CBER DMPQ CMC/Facility BLA Review Memorandum

BLA STN 125786/0

Name of product: BEQVEZ (fidanacogene elaparvovec, FidaVec)

Wei Wang, Ph.D., OCBQ/DMPQ/MRB3

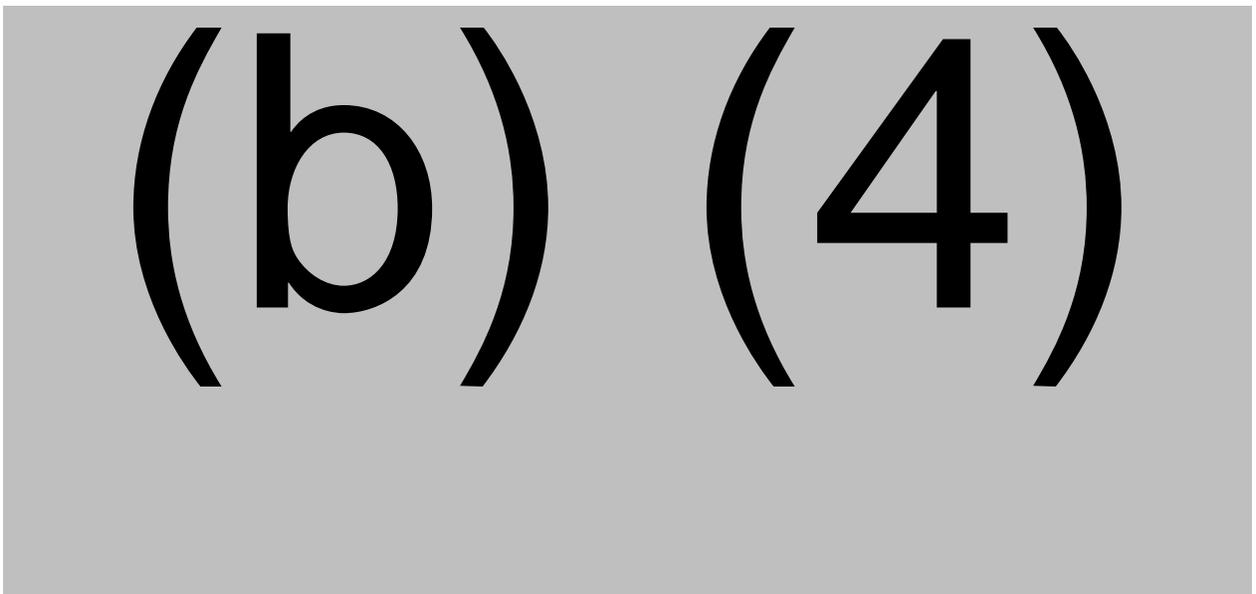
Review Comments: The information of DP manufacturing steps provided appears acceptable.
